Access Compliance Report

Public Rights-of-Way

Intersection ID: 10015096	Main Street: N_SHARON_AMITY_RD	Cross Street: N/A	Location: SE
ADA ID: CFBB6481CFB3	Ramp Type: PerpDiag	Initial Pass/Fail: Fail	Overall Compliance: No
		Severity Score: 12.5

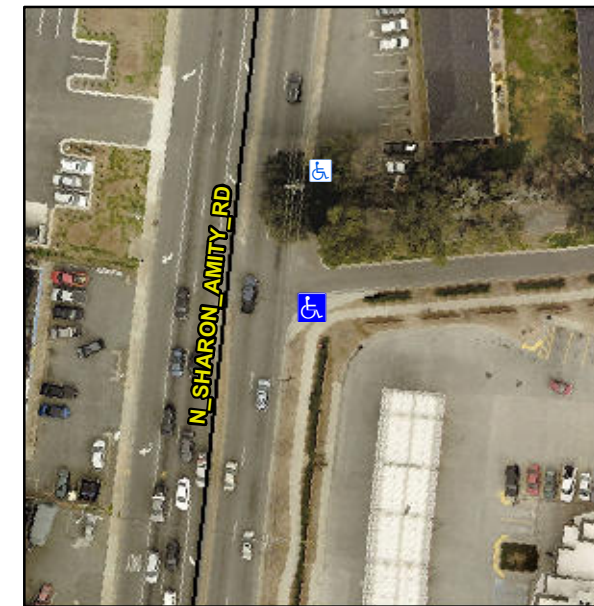
R304.2.2

Compliance	Description	Data	Compliance	Description	Data
N/A	Ramp Length (in)	96.0	No	Ramp Slope (%)	8.9
Yes	Ramp Width (in)	89.0	Yes	Ramp XSlope (%)	1.1
N/A	Flare Type LT	N/A	N/A	Flare Type RT	N/A
N/A	Flare Slope LT (%)	N/A	N/A	Flare Slope RT (%)	N/A
N/A	Flare Traversable LT?	N/A	N/A	Flare Traversable RT?	N/A
N/A	Landing Length (in)	N/A	N/A	DWS Provided?	N/A
N/A	Landing Width (in)	N/A	N/A	DWS Contrast?	N/A
N/A	Landing Slope (%)	N/A	N/A	DWS Length (in)	N/A
N/A	Landing X Slope (%)	N/A	N/A	DWS Full Width?	N/A
N/A	Landing Curb? (Y/N)	N/A	N/A	DWS Offset (in)	N/A
N/A	Shared Landing?	N/A			
N/A	Gutter Ponding?	N/A	N/A	Gutter Slope (%)	N/A
N/A	Gutter Lip Ht (in)	N/A	N/A	Gutter X Slope (%)	N/A
N/A	Painted X Walk1?	No	N/A	Painted X Walk2?	No
	X Walk 1 Direction	To N		X Walk 2 Direction	To W
N/A	X Walk 1 Width (in)	N/A	N/A	X Walk 2 Width (in)	N/A
	X Walk 1 Slope (%)	2.3		X Walk 2 Slope (%)	1.3
	X Walk 1 X Slope (%)	3.5		X Walk 2 X Slope (%)	1.9

Remove & Replace Curb Ramp With Two New Directional Ramps or Equivalent.
